# UNITED STATES PATENT AND TRADEMARK OFFICE

APPLICATION NO.	FILING DATE	FIRST NAMED INVENTOR	ATTORNEY DOCKET NO.	CONFIRMATION NO.
10/772,629	02/04/2004	Myan Spaccarelli	7294-101	5652
167	7590	12/21/2005	EXAMINER	
FULBRIGHT AND JAWORSKI LLP 555 S. FLOWER STREET, 41ST FLOOR LOS ANGELES, CA 90071			KIM, SANG K	
			ART UNIT	PAPER NUMBER
			3654

**Office Action Summary**

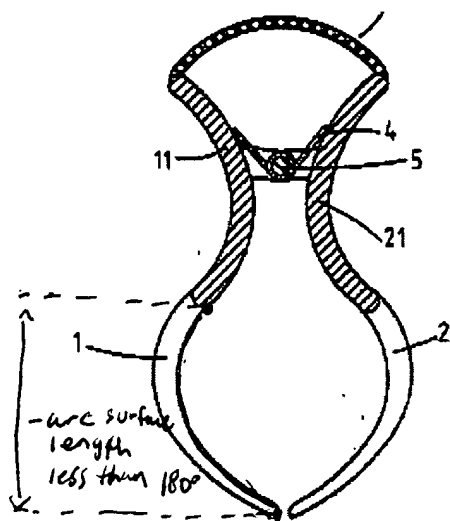
Lee '096 shows a device comprising: opposing clamp members 1, 2 hingedly connected and biased 4 toward a closed position, wherein each opposing clamp member includes a curved inner surface with one or more fingers extending over the material, and handles 7 being adapted to leverage the opposing clamp members into an open position, see figure 7. Note: a recitation for using the device for clamping an unused toilet paper roll or any other roll to prevent unwinding is intended used of the claimed device. If the prior art structure is capable of performing the intended use, then it meets the claim.

With respect to claims 7 and 12, each arcuate surface has an arc length of less than 180 degrees is inherently taught by Lee '096 since each arcuate surface measured from one end to the other end does not extend more than 180 degrees, see figure 6 below:
